50 CambridgePark Drive Residences

Cambridge, MA / Supplement to Special Permit Application / August 1, 2018

RE: *Supplemental Application for 50 CambridgePark Drive*

SUPPLEMENT TO SPECIAL PERMIT APPLICATION

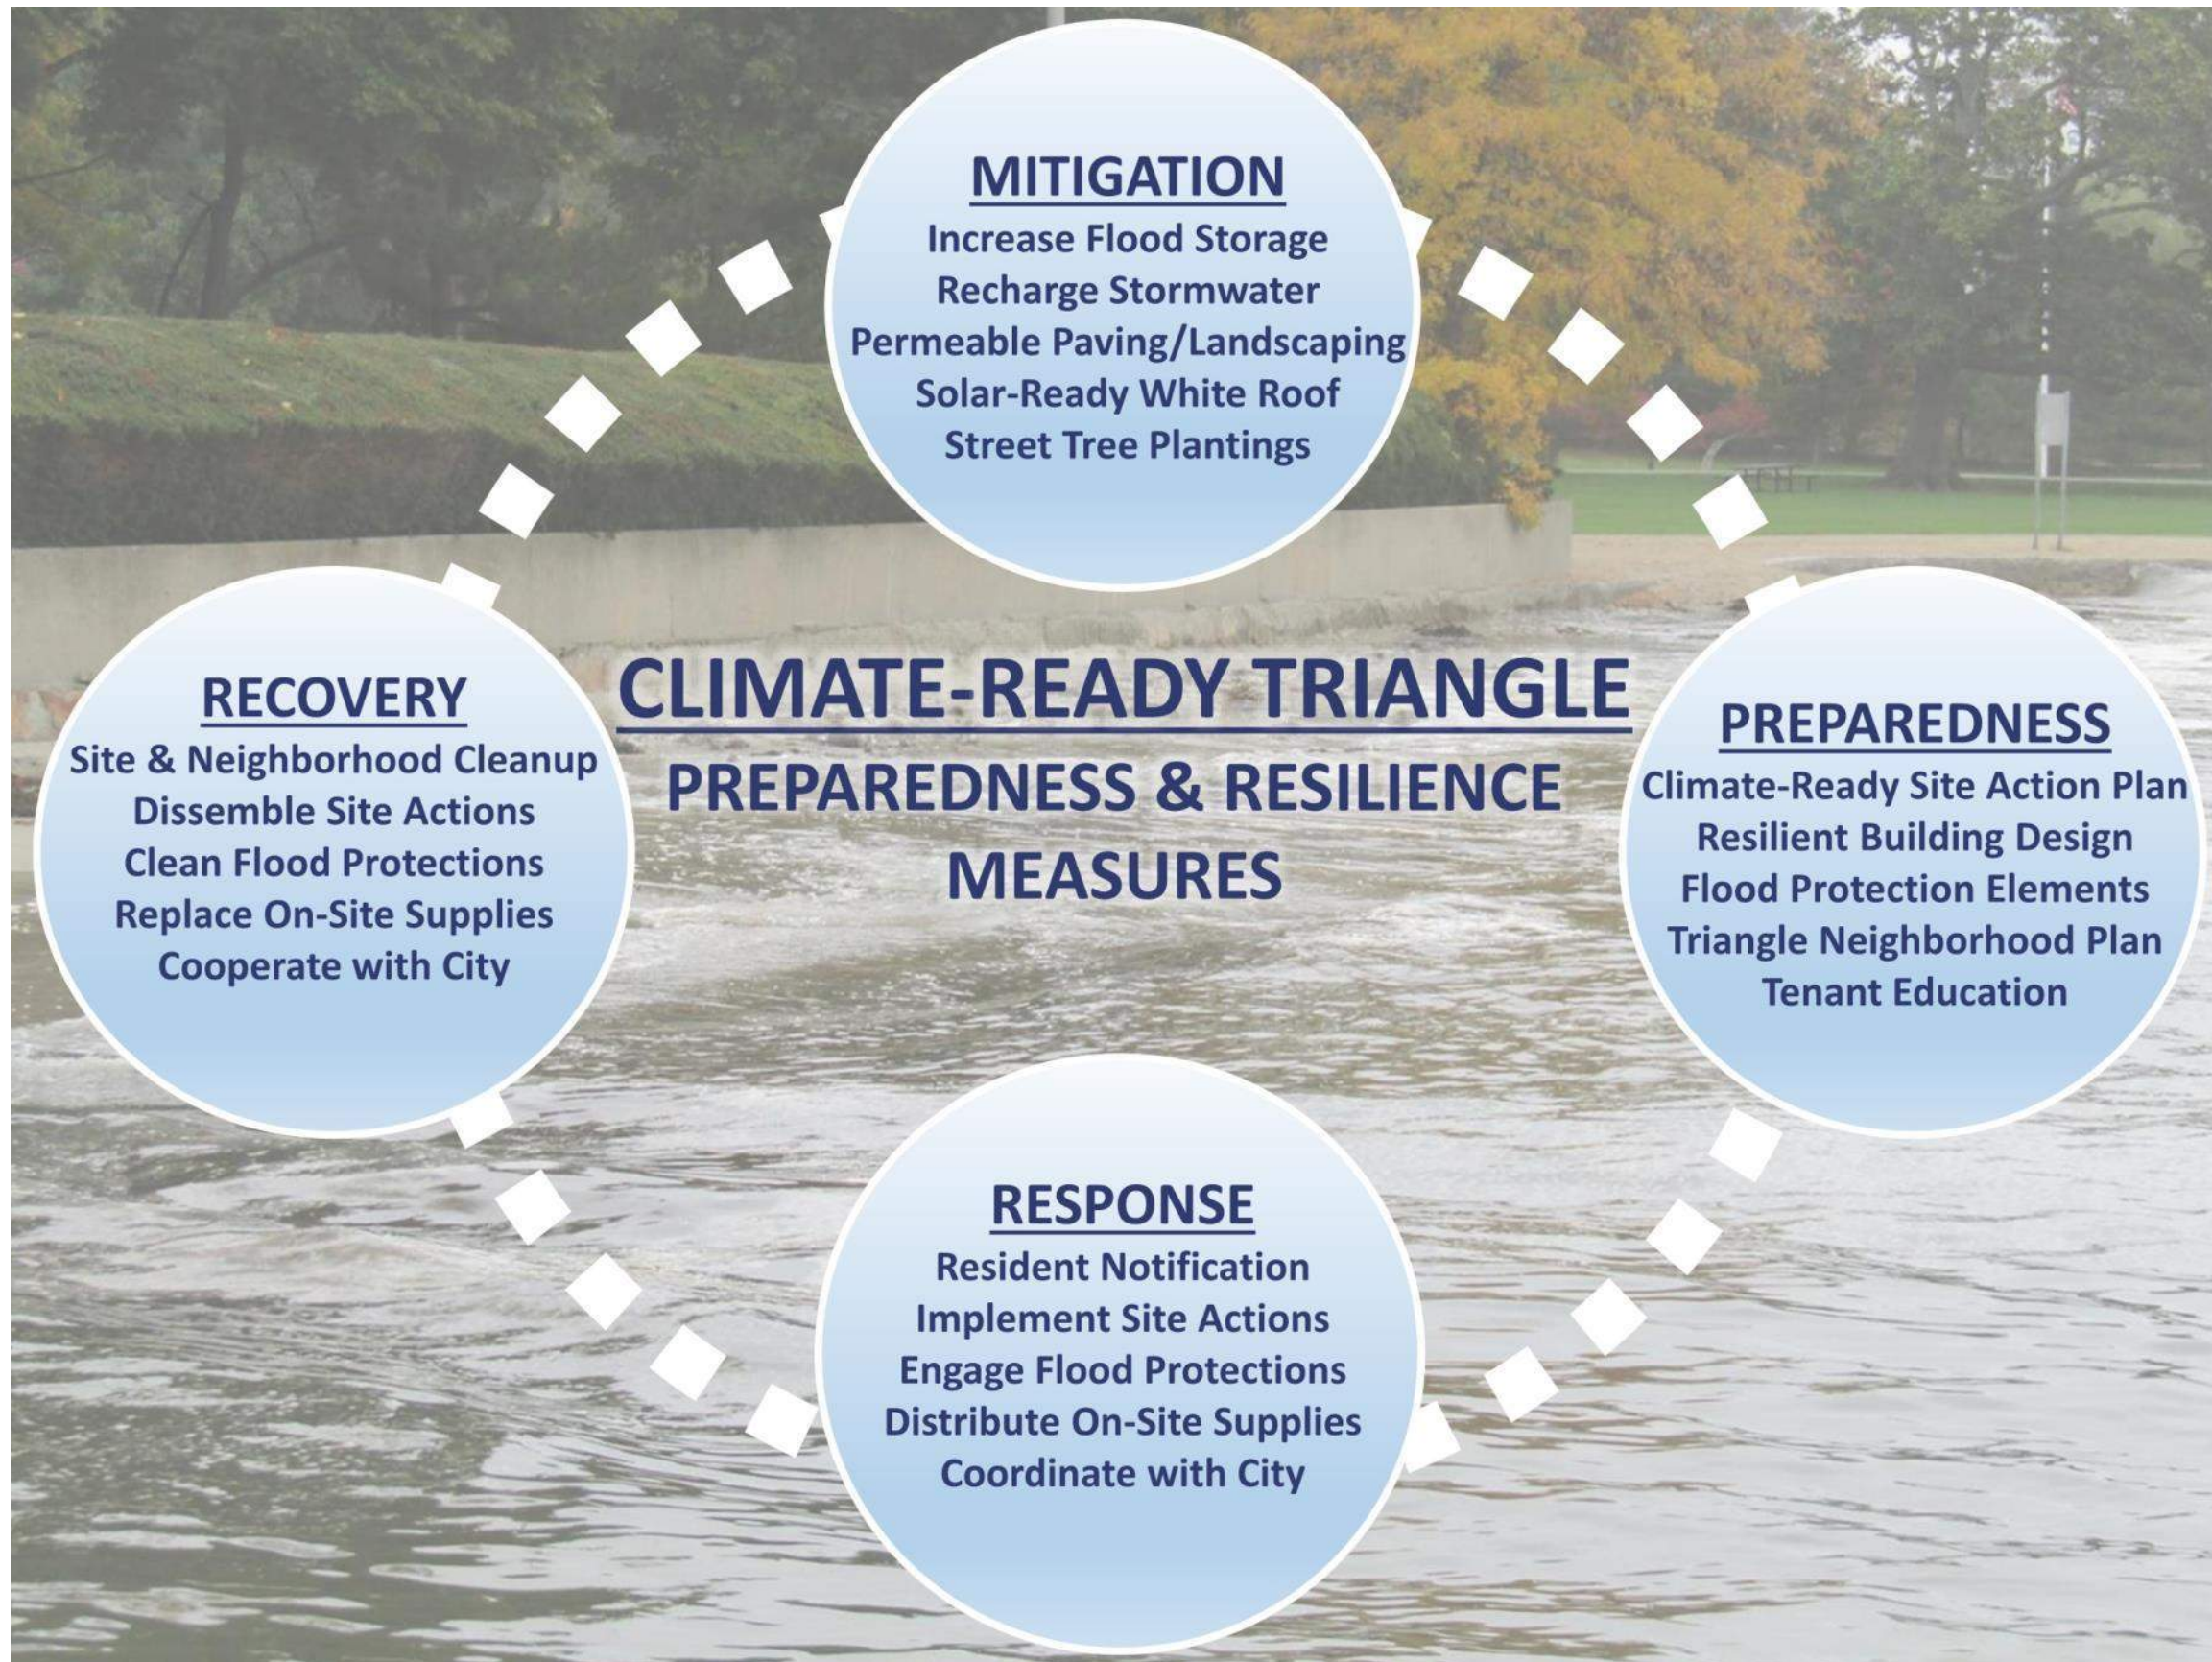
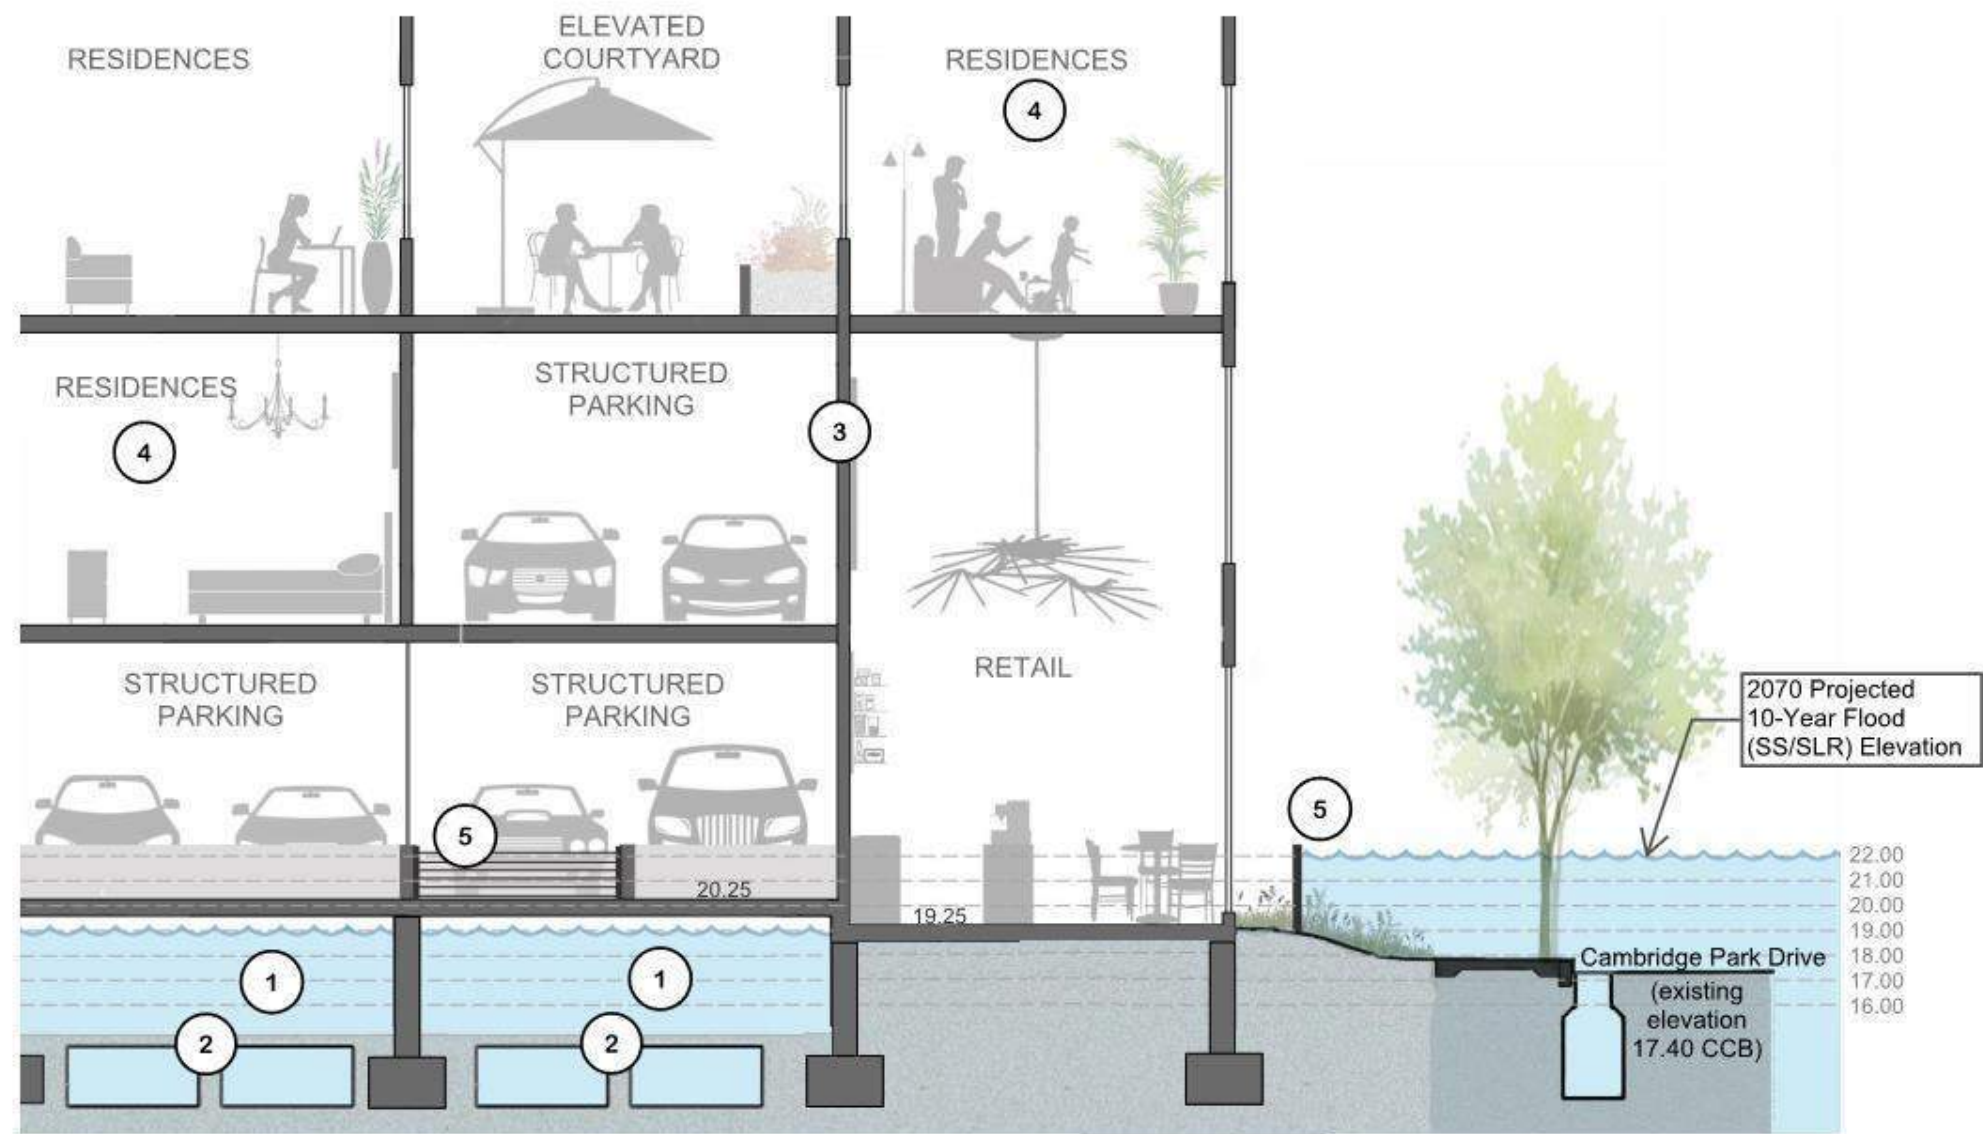
How does this redevelopment project respond to the recommendations of the City of Cambridge's on-going climate resiliency work as documented in the *City of Cambridge Climate Change Vulnerability Assessment (CCVA)* and the *DRAFT City of Cambridge Climate Change Preparedness and Resilience Plan*?

ANSWER The 50 CambridgePark Drive project has incorporated the recommendations and projected flood elevations from the *City of Cambridge Climate Change Vulnerability Assessment (CCVA)* and the *DRAFT City of Cambridge Climate Change Preparedness and Resilience Plan* into the design of the Project as shown on the attached graphics. In addition, the Project team has drafted a DRAFT Site Action Plan in coordination with the City of Cambridge Department of Public Works (DPW) staff to address preparedness, such a flood protection measures, on-site supplies, and other measures to promote the resiliency of the building and its occupants. Flood protection measures are further detailed in Questions 3, 6 and 9.

- ① Flood Storage Area - allows natural passage of flood water below structure through open grates along eastern building perimeter. Increased flood storage for present and future conditions (in excess of projected 2070 10-year flood elevation).
- ② Stormwater infiltration - reduction in impervious area on-site and 220 precast concrete galley chambers designed for groundwater recharge of roof runoff.
- ③ Green Building Design - will meet and exceed requirements of LEED (Leadership in Energy and Environmental Design) Silver certification and incorporate a solar-ready energy efficient white roof.
- ④ No Residential Units at Ground Level
- ⑤ Building Flood Protection Measures - temporary perimeter and gateway barriers to 2070 projected 10-year (based on SLR/SS) flood elevation (project will strive to exceed the City of Cambridge recommendations).

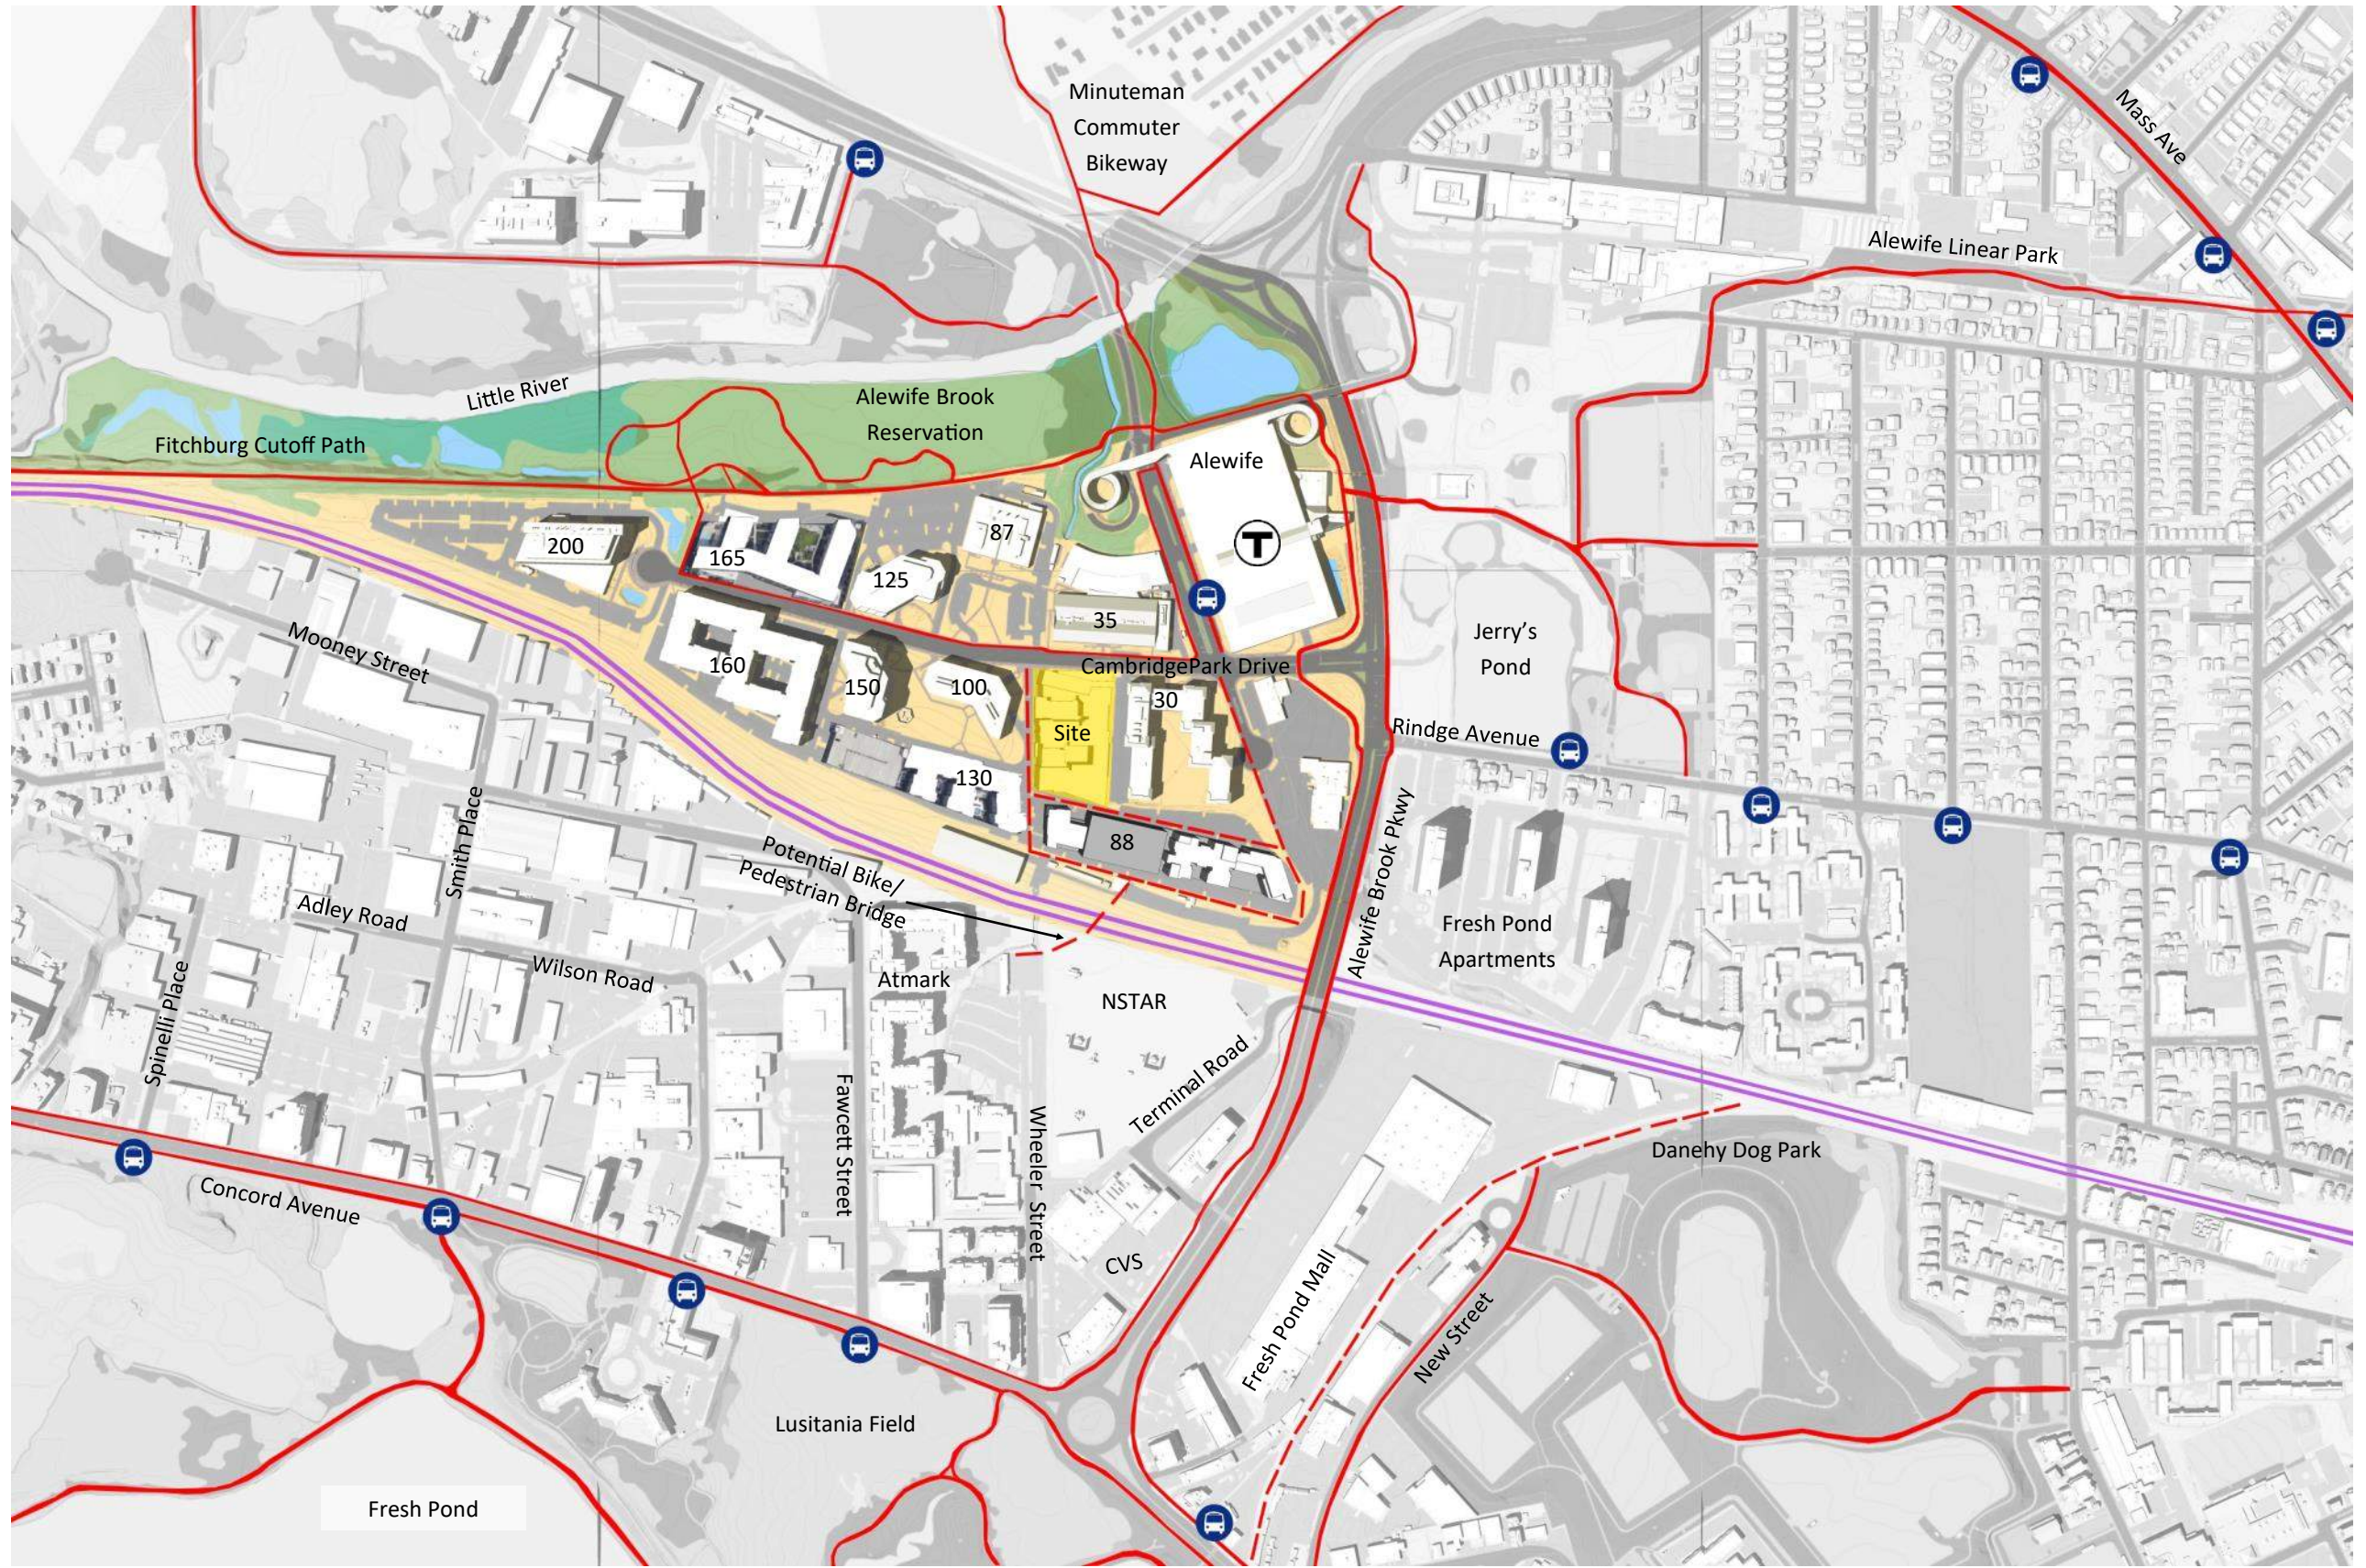
How will this project connect to the existing transportation network in the area?

ANSWER 50 CambridgePark Drive is a truly transit-oriented development, located nearly as close as possible to the MBTA Alewife station, where Red Line service and capacity will be substantially increased in the near future by signal upgrades and the addition of 252 new cars. These improvements are anticipated to reduce peak hour headways from 4.5 minutes to 3 minutes and accommodate approximately 7,000 additional passengers per hour.

The new bicycle lane to be constructed on CambridgePark Drive by the Project will fill in a missing connection within both the regional and local bicycle networks, including the nearby Minuteman Commuter Bikeway, the Alewife Greenway, and the Linear Park. In addition, the new street will provide an important connection a future pedestrian/bicycle bridge over the MBTA commuter rail tracks, further enhancing pedestrian and bicycle connectivity within the Triangle and beyond.
